ADDENDUM NO. 2

ROAD SURVEILLANCE & MONITORING DUVAL ST MALLORY SQUARE & OUTER MOLE ITB #18-035

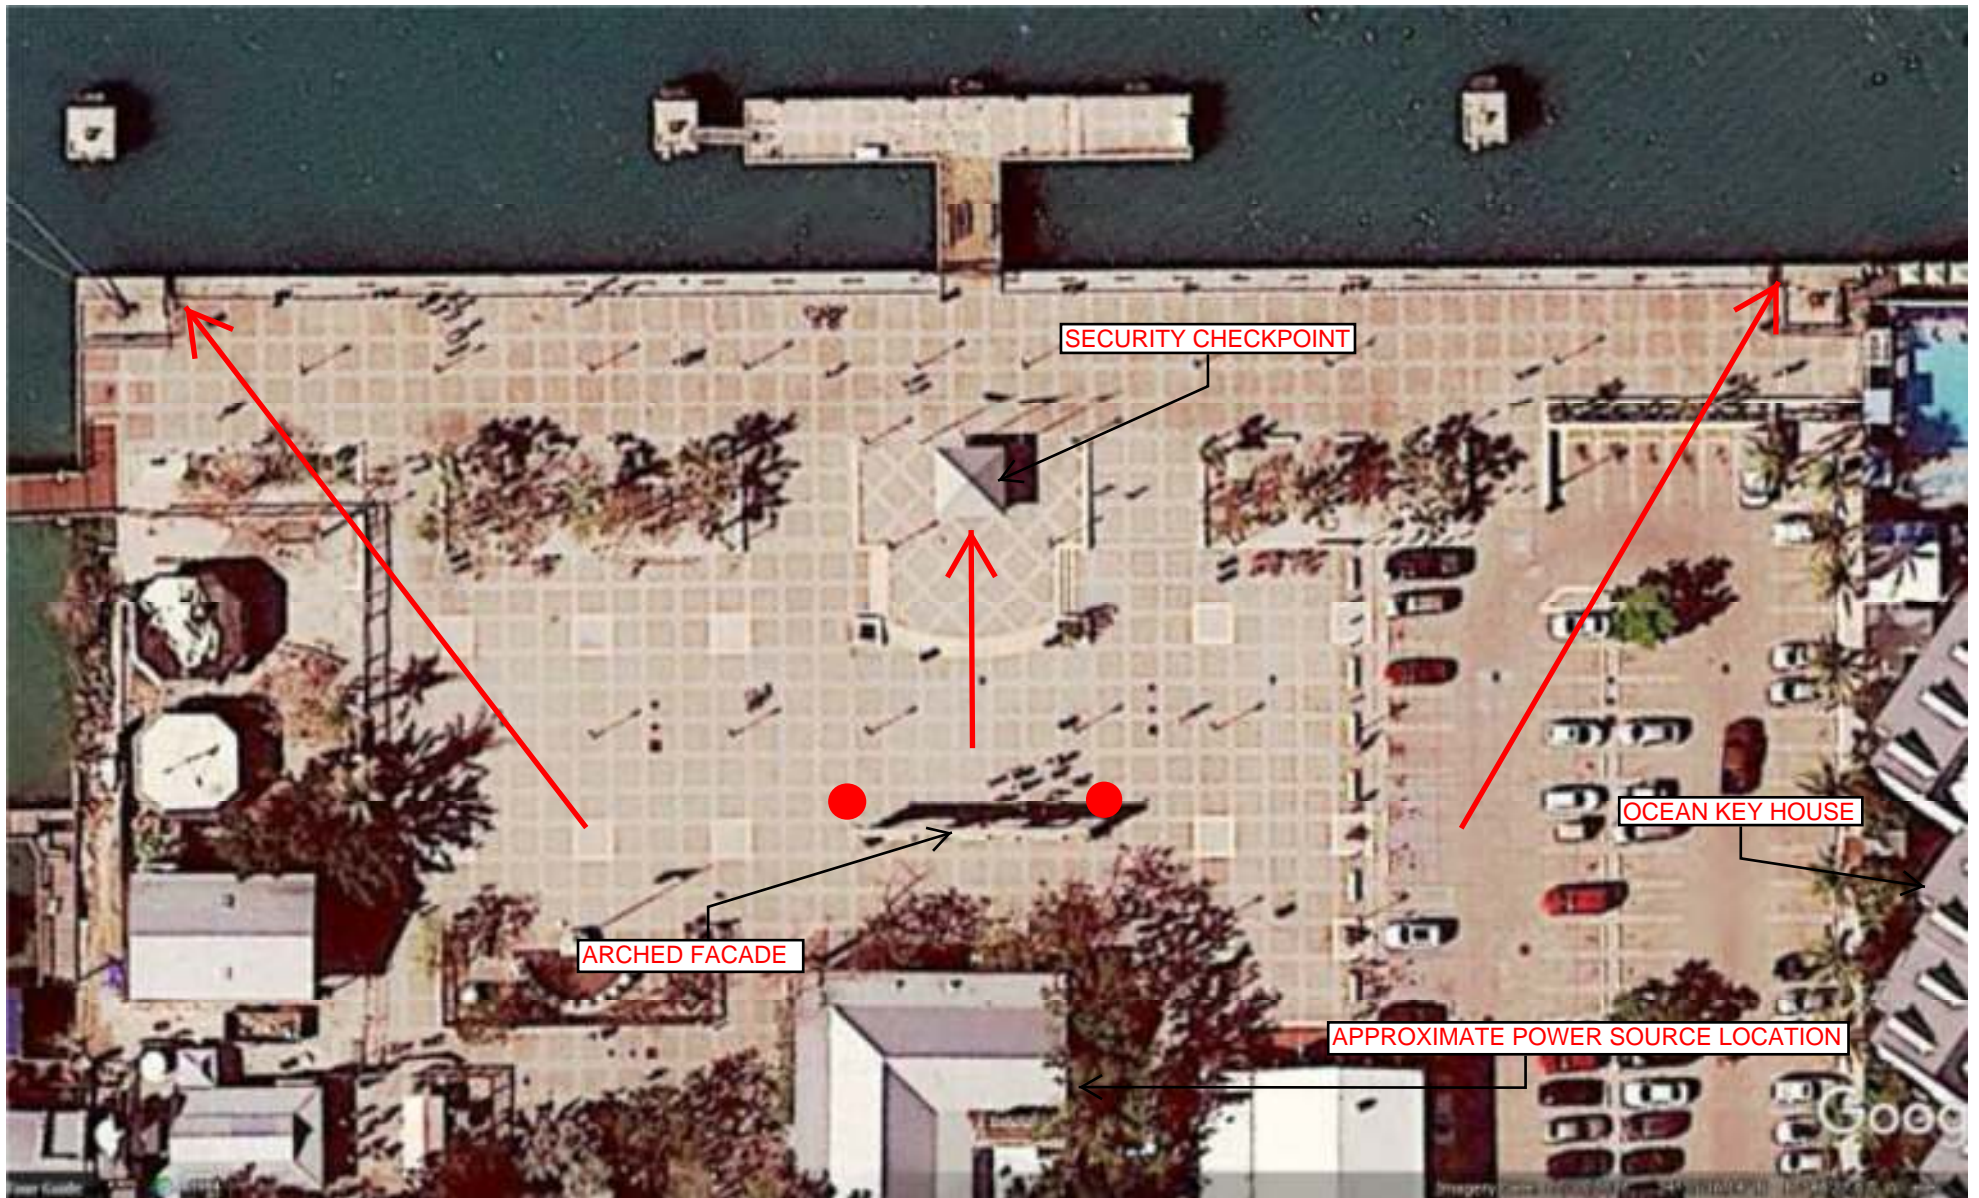
28. Provide overview picture of all locations mentioned in ITB #18-035

All locations have been previously provided.
